EROSION AND SEDIMENT CONTROL INSPECTIONS

Project name: Insulator Drive

DPW plan ID: BCNR 10258

Inspection date: 9-12-2024

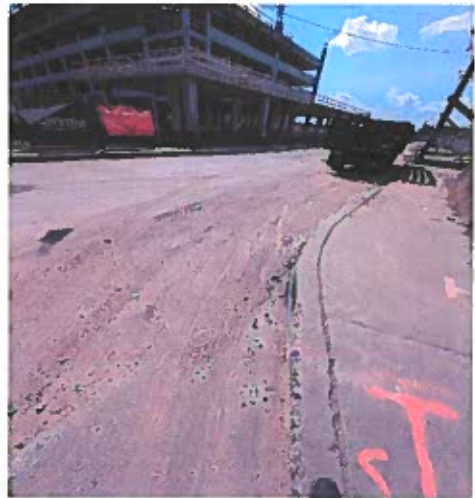
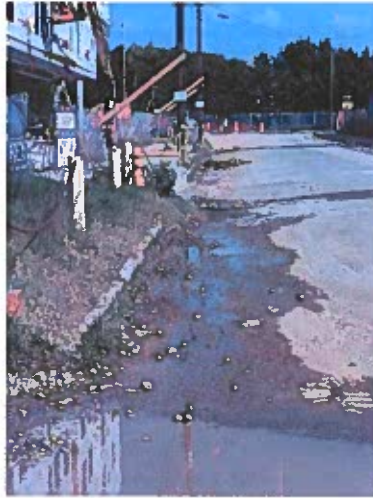
1. DPW Inspector met with Jason w/ SEH.
2. **FINE ISSUED \$200.00**
 - a. WILLFUL DESTRUCTION OF AN SEDIMENT CONTROL DEVICE – \$100.00
 - b. FAILURE TO MAINTAIN PERIMTER SEDIMENT CONTROL DEVICE – \$100.00

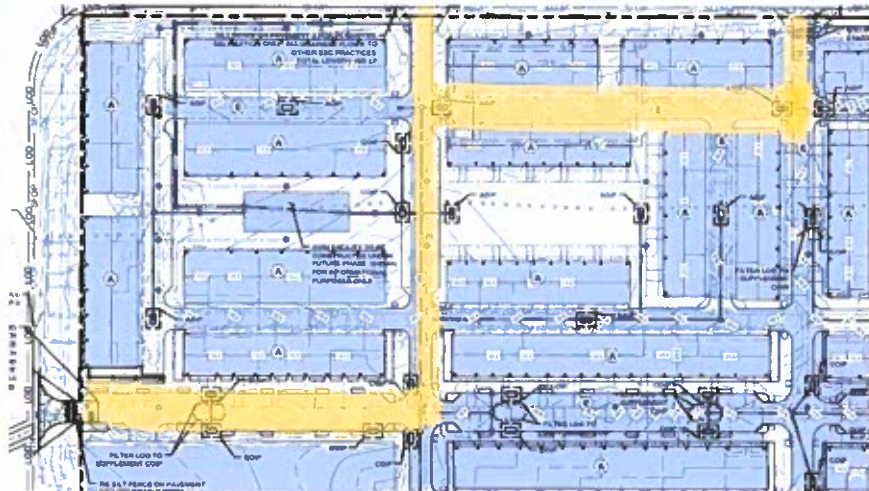
3. Excessive sediment on Insulator Drive. Sweep immediately. Continued instances of this will result in additional fines. (Final Warning)

4. Please start sweeping the interior roadway at these locations. Sediment build-up is increasing, and these points of egress have no E&S controls.

5. Continue sweeping Insulator Drive. Tracking is occurring in Nicks parking lot as well at the section of Insulator Drive by the Marina.

All items shall be fixed immediately. Due to the nature of Item 2 in section E, penalty fines have been issued in the amount of \$200.00.
